## Accessibility Survey

## City of Downey Meadow Road - Birchdale Avenue To Lakewood Boulevard

Date of Inspection  
3/17/2017

#### Sidewalk West Of Lakewood Boulevard @ 33.918946730889, -118.138990402222

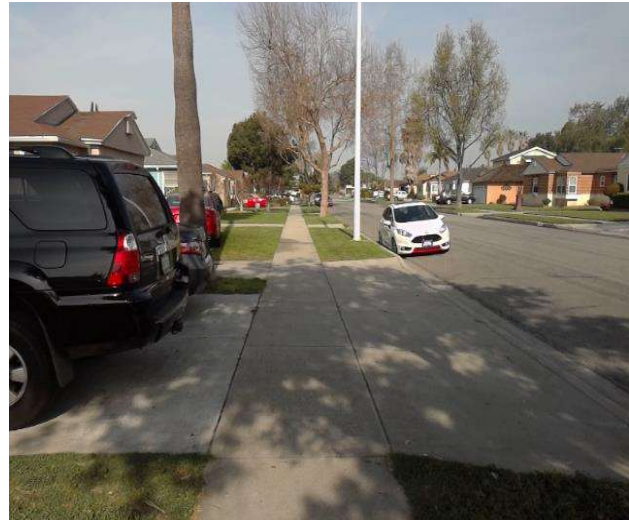
Sidewalk cross slope is not compliant.

**On-Site Finding** 3.70 percent for 92.00 feet

Repave the sidewalk surface with the recommended cross slope.

Recommendation Up to 2.08 percent
